PATRIOT PLACE SUBDIVISION - REPLAT A

A REPLAT OF LOTS 1 & 2, PATRIOT PLACE, LOCATED IN THE SOUTHWEST QUARTER OF SECTION 11,
TOWNSHIP 11 SOUTH, RANGE 67 WEST OF THE 6TH P.M.,
COUNTY OF EL PASO, STATE OF COLORADO

FINAL PLAT
PATRIOT PLACE SUBDIVISION - REPLAT A

Final Plat Drawings_V1.pdf Markup Summary

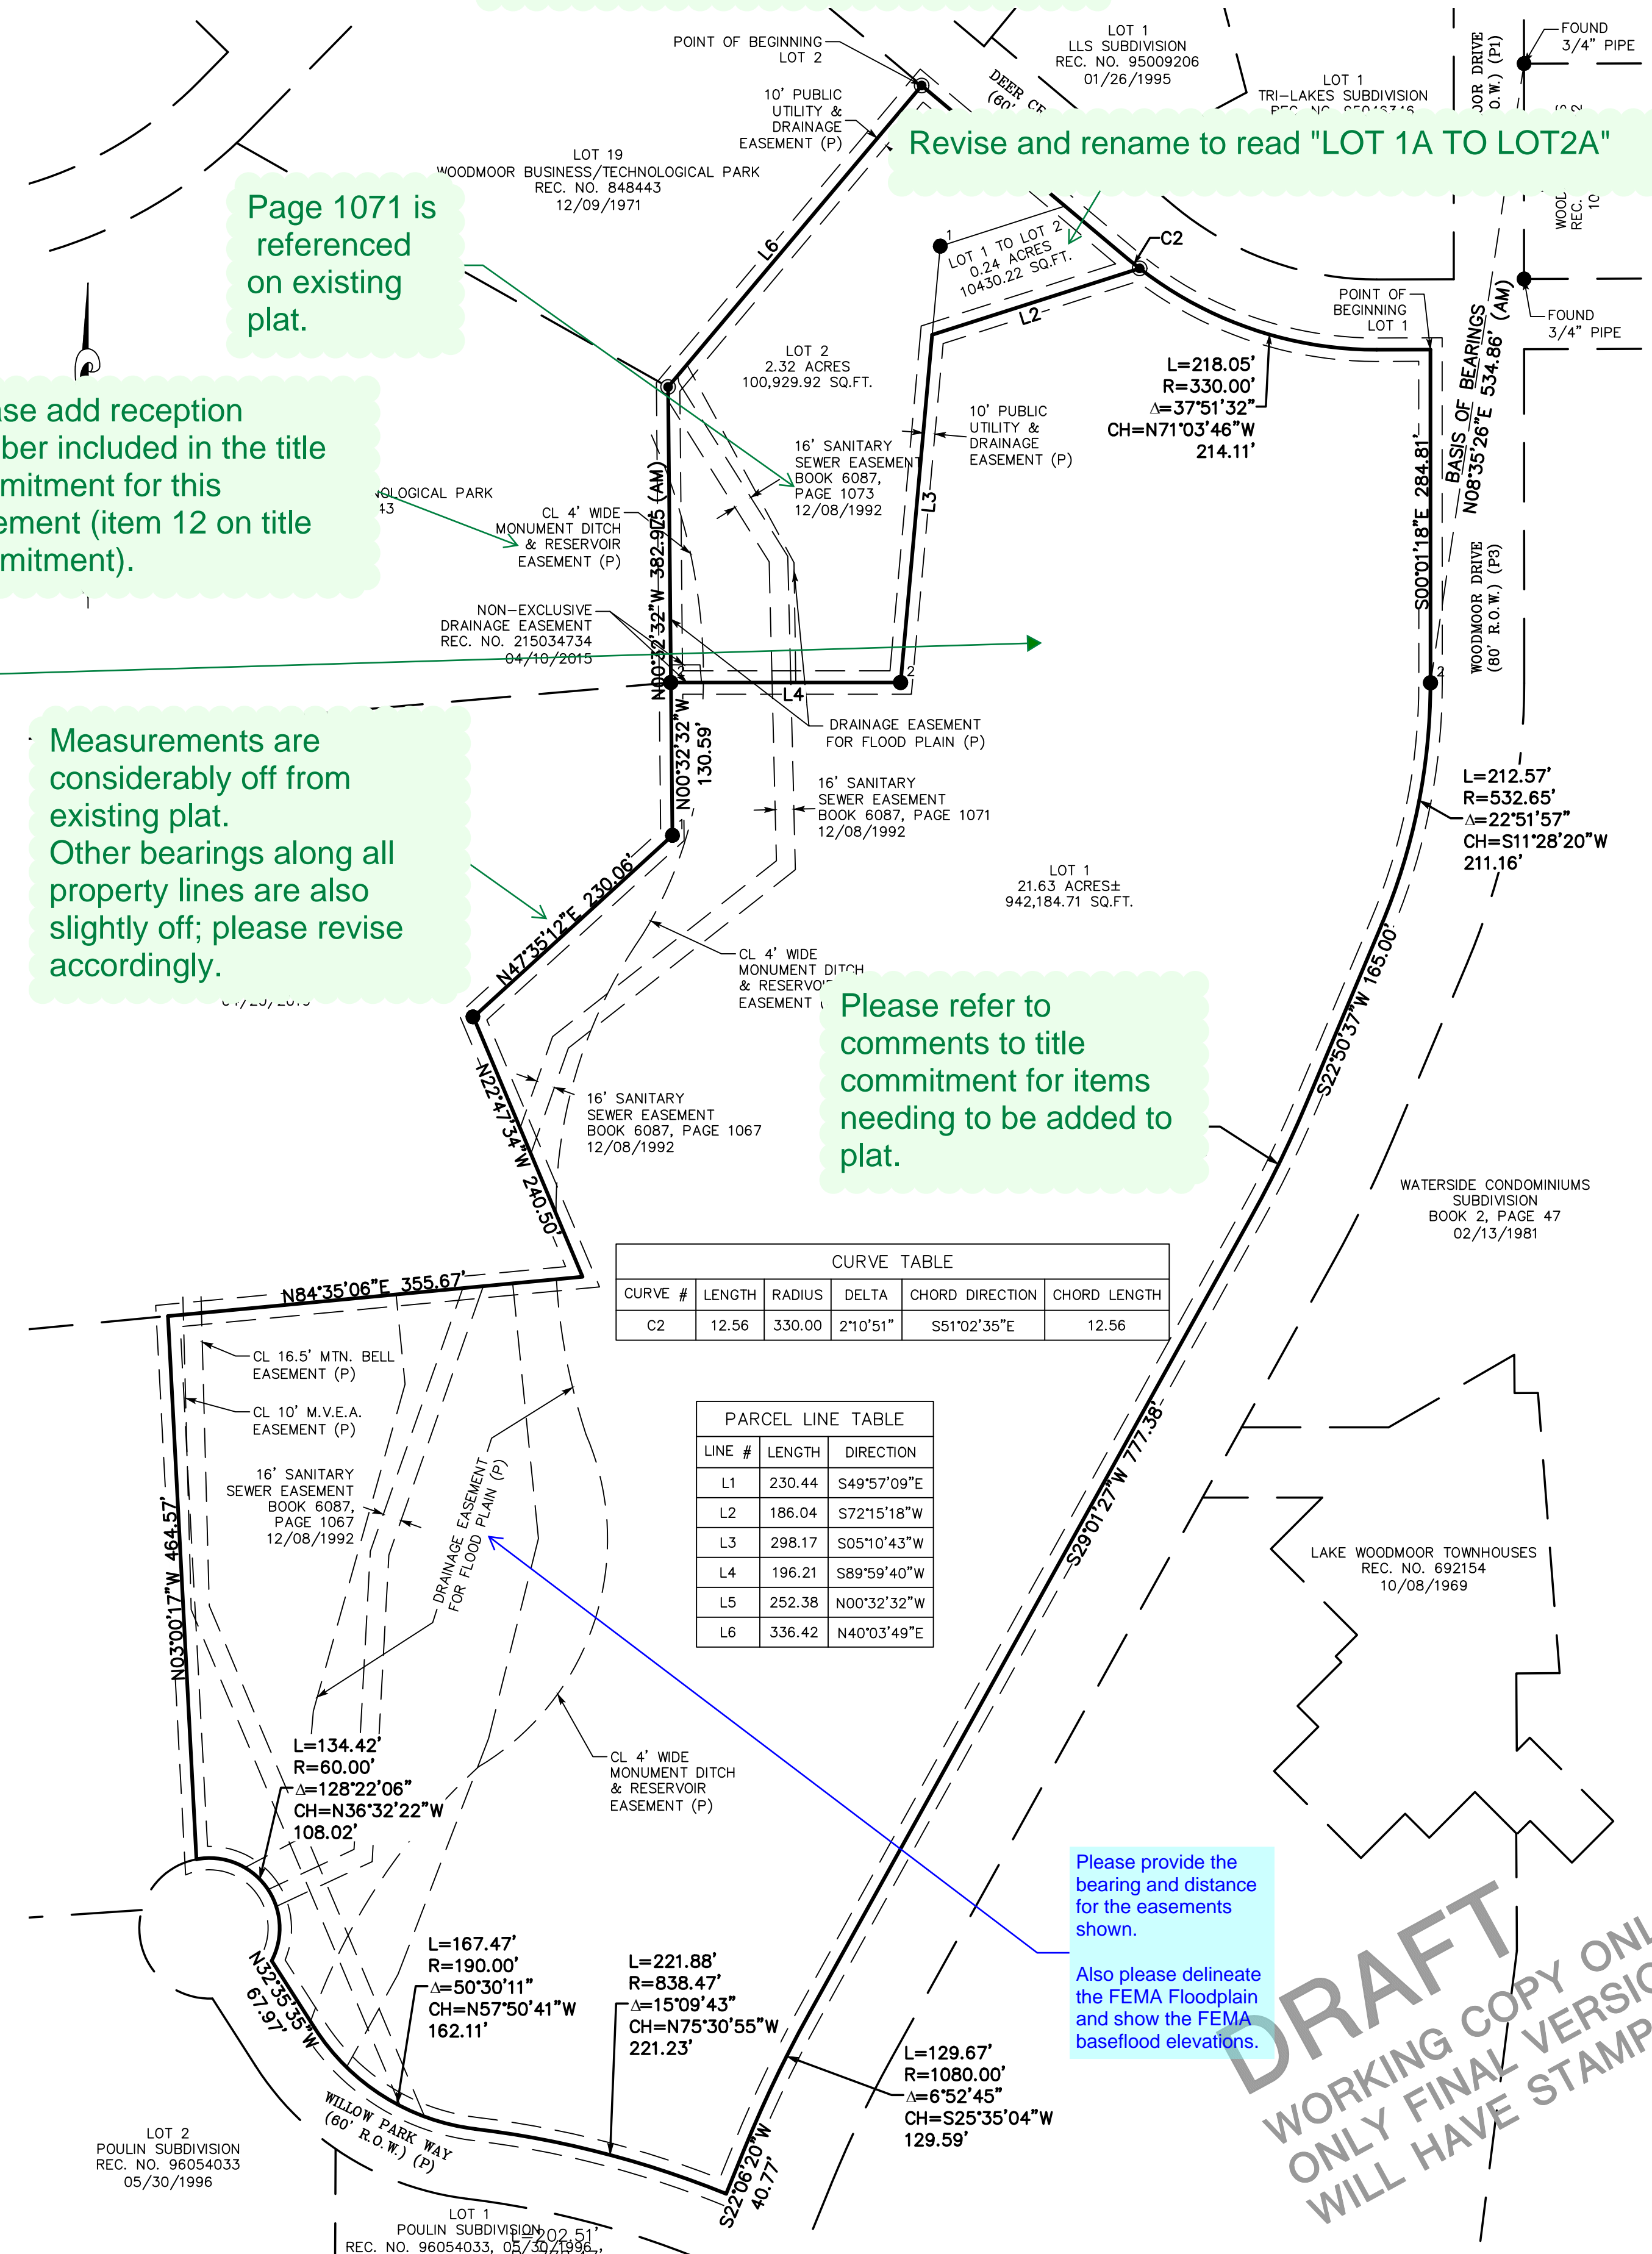
Please add all of the previous plat notes shown on the current plat (from 1993) in addition to the following:
-add reference to the covenants

Please revise title to say:
"PATRIOT PLACE SUBDIVISION - A"

Bearings on proposed plat do not match those on the existing plat, as such this legal description will also need to be revised accordingly along with the plat and closures sheet.

Add second signature block for second owner.

Remove Depositing Certificate altogether; not needed.

Add the following plat notes:

Please add the following note(s):
-All property owners are responsible for maintaining proper storm water drainage in and through their property. Public drainage easements as specifically noted on the plat shall be maintained by the individual lot owners unless otherwise

SHEET 2 OF 2

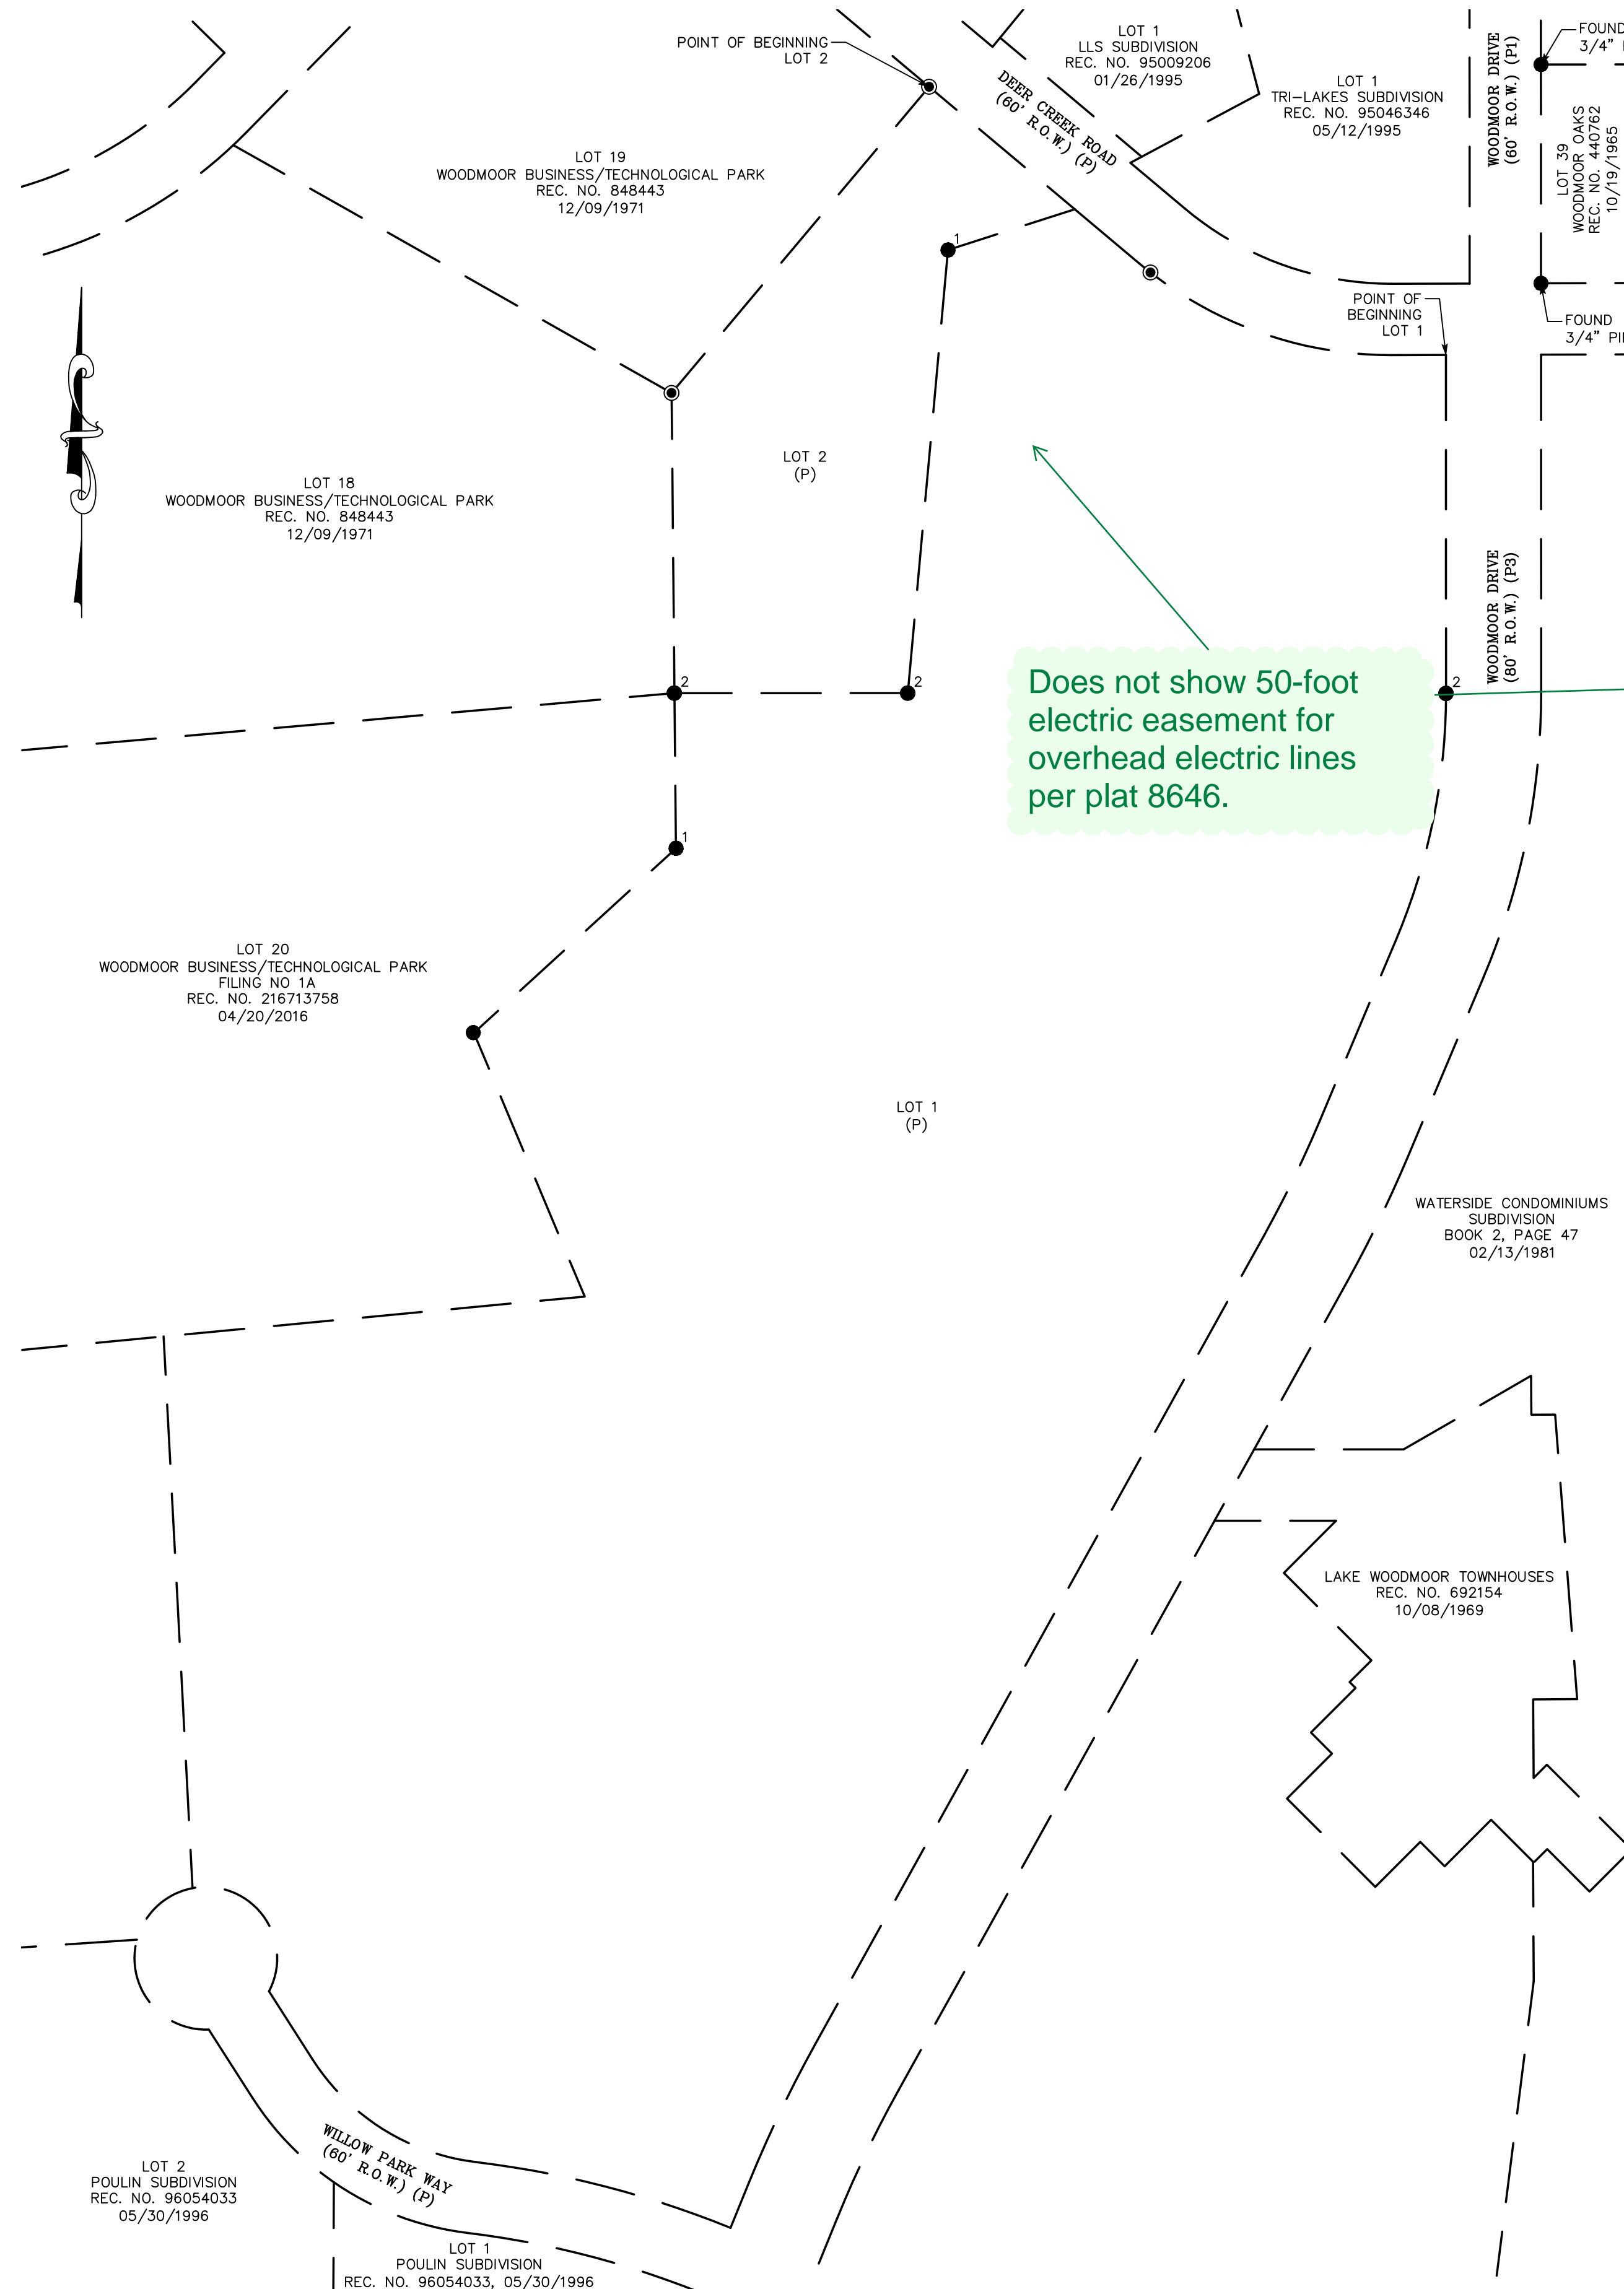
Please revise title to say:
"PATRIOT PLACE SUBDIVISION - A"

Revise and rename to read "LOT 1A TO LOT2A"

Page 1071 is referenced on existing plat.

Please add reception number included in the title commitment for this easement (item 12 on title commitment).

Does not show 50-foot electric easement for overhead electric lines per plat 8646.

Measurements are considerably off from existing plat. Other bearings along all property lines are also slightly off; please revise accordingly.

Please refer to comments to title commitment for items needing to be added to plat.

Please provide the bearing and distance for the easements shown.
Also please delineate the FEMA Floodplain and show the FEMA baseflood elevations.
